Product Change Notification – 2025/09

Product Line:	etherCON®	Part No:	NE8MX6*
Piece Part:	Bushing	Part No:	1014016
Engineering Change Request:	2022-0940	Date:	10.06.2025
Comments:	Bushing redesigned		
Affected products:	NE8MX6 NE8MX6-B NE8MX6-B-D NE8MX6-B-T NE8MX6-D NE8MX6-T		
First shipment of modified product:	Q49

Engineering Change Notice

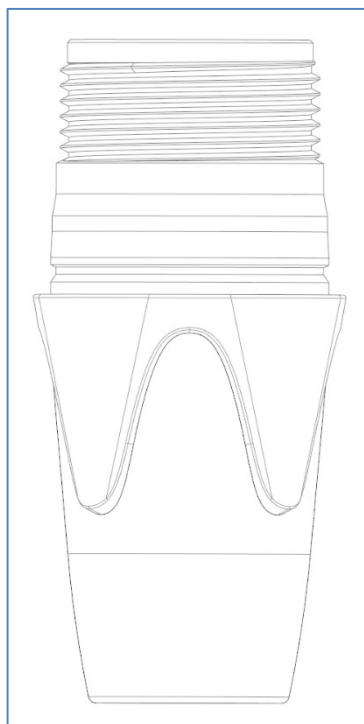
Neutrik logo has been added to exterior bushing, to ensure better recognizability.
